COLERAIN TOWNSHIP ZONING COMMISSION
Regular Meeting
Tuesday, March 17, 2015 - 7:00 p.m.

STAFF REPORT:

FINAL
DEVELOPMENT PLAN
CASE #: ZA 2014-0009
CHICK-FIL-A
MARCH 17, 2015

**PRELIMINARY ENGINEERING PLANS
COLERAIN COMMONS (CINCINNATI)**
**9470 COLERAIN AVENUE
HAMILTON COUNTY
STATE OF OHIO**

SITE PLAN DESIGN NOTES & KEY PLAN

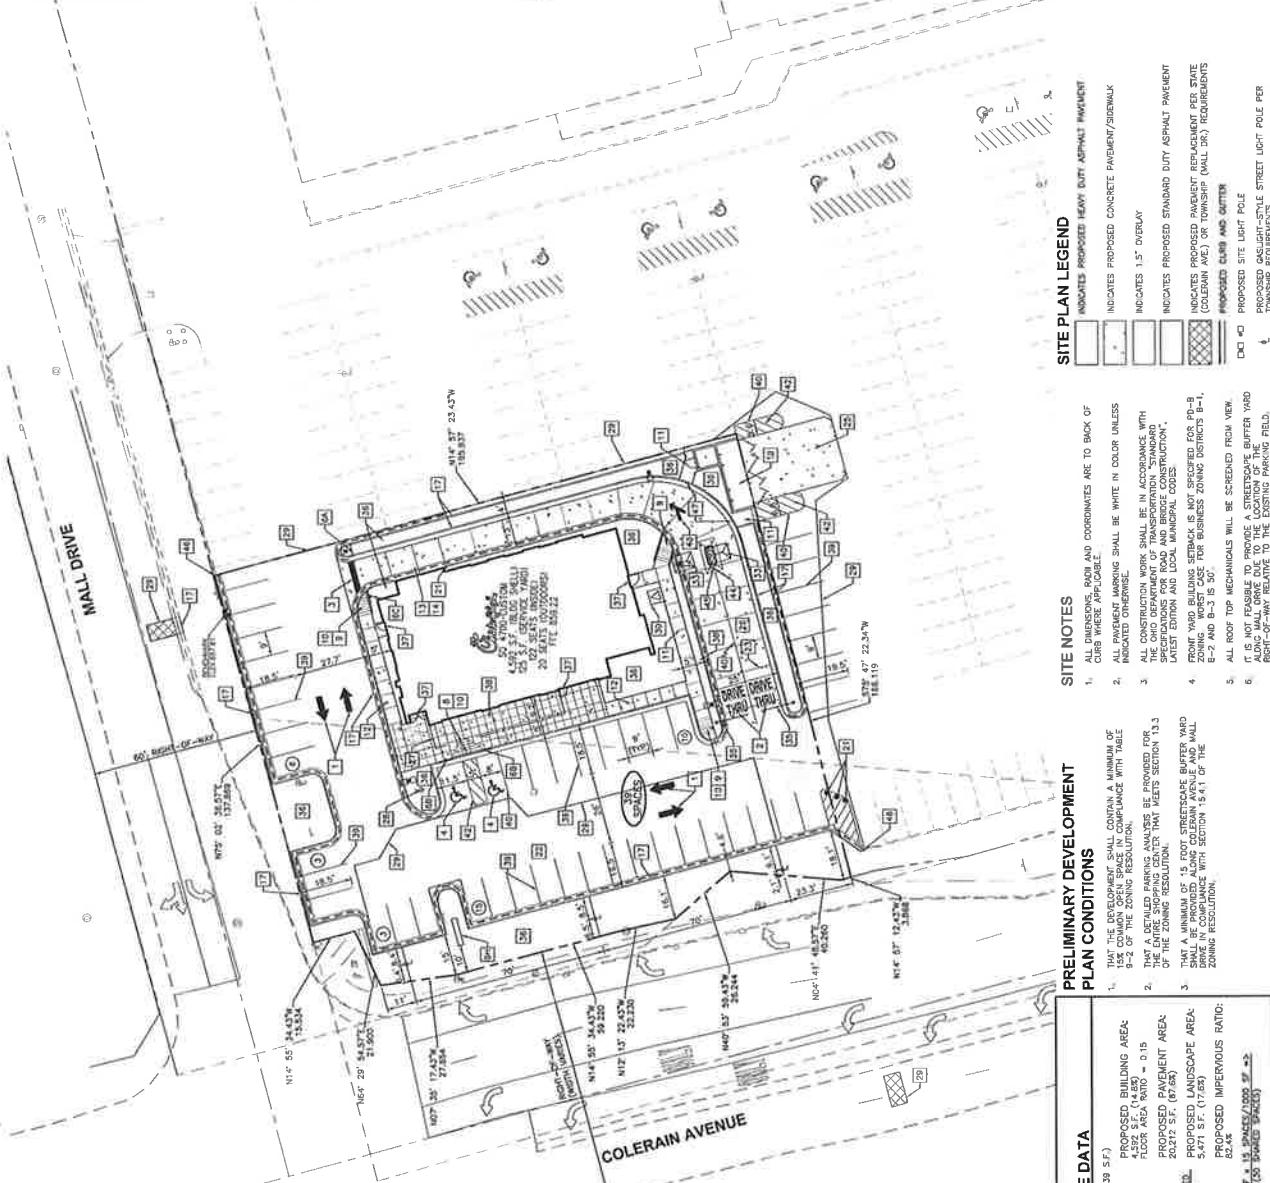
- Due to the shape of the Right-of-Way, the applicant proposes an irregular streetscape buffer area along Colerain Avenue that meets the intent of the streetscape buffer requirement. On Mall Rd., the Trustees are permitting the applicant to make improvements within the ROW consistent with the landscaping requirements of the streetscape buffer area.
- Applicant proposes 7 trees on Colerain where 7 are required.
- Applicant proposes 3 trees on Mall where 5 are required.
- Applicant proposes 75 SF of landscaped area on Colerain where 265 SF is required
- Applicant proposes no landscaped area on Mall where 205 SF is required.

- LANDSCAPING (CONTINUED)**
- Applicant proposes to landscape approximately 11% of the parking area where 15% is required.
 - Applicant proposes two parking islands which are required to have at a minimum 1 tree and 2 shrubs. The parking island on mall road has no trees or shrubs. The parking island on Colerain has 7 shrubs.
 - Applicant proposes a parking island on Colerain that is approximately 7.5' in width where 9 feet are required.

- PARKING**
- Applicant proposes 39 parking spaces (37 regular spaces and 2 accessible spaces). The zoning resolution proscribes 15 spaces per 1,000 SF of gross floor area or 69 spaces in this case. The applicant proposes that 30 of the required number of spaces to be designated as shared spaces.
 - No shared parking agreement was submitted.
 - The applicant proposes parking stalls with dimensions ranging from 9' by 16.5' and 9' by 18.5' where a minimum of 9' by 19' is required.
 - The applicant proposes one 26' two-way drive aisle on the east side of the building and one 28.7' drive aisle on the north side of the building where a minimum of 24' is required.
 - The applicant does not show the number of stacking spaces for the two drive-thru aisles. A minimum of 8 stacking spaces per lane are required.

1. Applicant shall shorten the width of the drive aisle to not less than 24' to allow parking stalls to meet the minimum length of 19' per §13.4.3 (A) of the zoning resolution.

2. Applicant shall illustrate the required number of stacking spaces in the drive-thru aisles per §13.5.1 of the zoning resolution.
3. Any roof-based mechanical equipment that may be visible shall be screened from view per §12.11 of the zoning resolution.

7. Applicant shall update the landscaping plan to show 265 SF of landscaped area in the Streetscape Buffer Yard on Colerain Ave.
8. Applicant shall update the landscaping plan to show a minimum of 1 tree and 2 shrubs in each parking island

9. Applicant shall update the site plan to show parking islands with a minimum width of 9'
10. Applicant shall comply with the rules found in §13.4.7 (B) of the zoning resolution related to shared parking.

OPEN SPACE SUMMARY

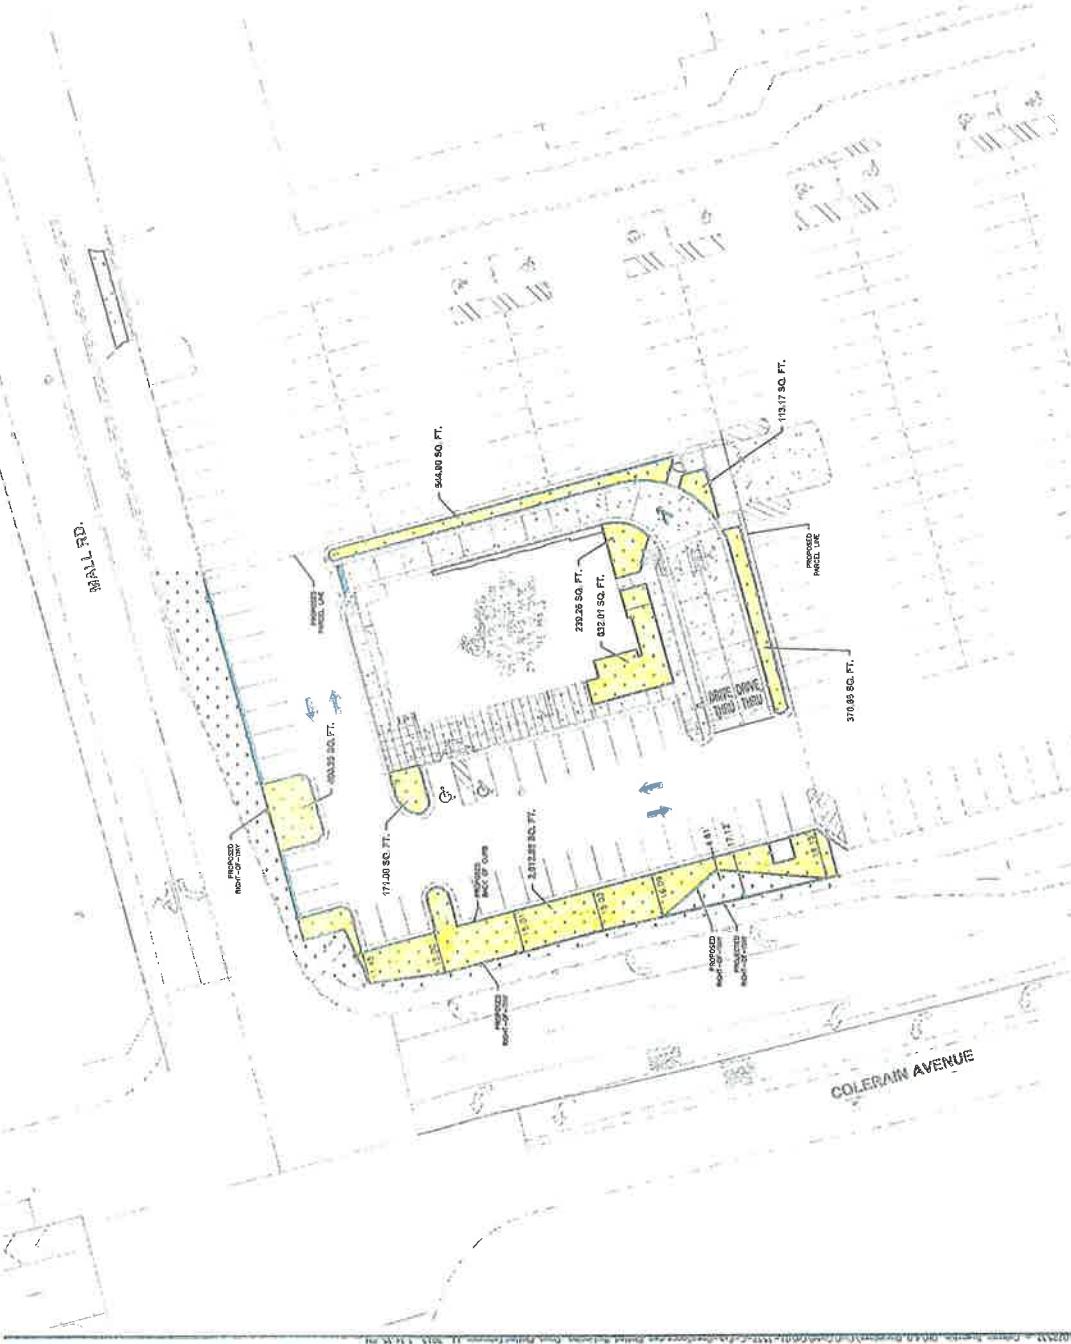
- The zoning resolution requires that all roof-based mechanical equipment be screened from view with a parapet wall with cornice. It is not clear from the drawings that the mechanicals are appropriately screened.
- The applicant proposes 16.67% open space on the property which exceeds the required 15%
- The applicant provided a parking analysis of the larger site.

5. Applicant shall obtain a revokable license from the Township to make landscaping improvements within the right-of-way per condition #4 of the PDP
6. Applicant shall update the landscaping plan to show 5 trees and 205 SF of Landscaped Area in the landscaped portion of Mall Rd.
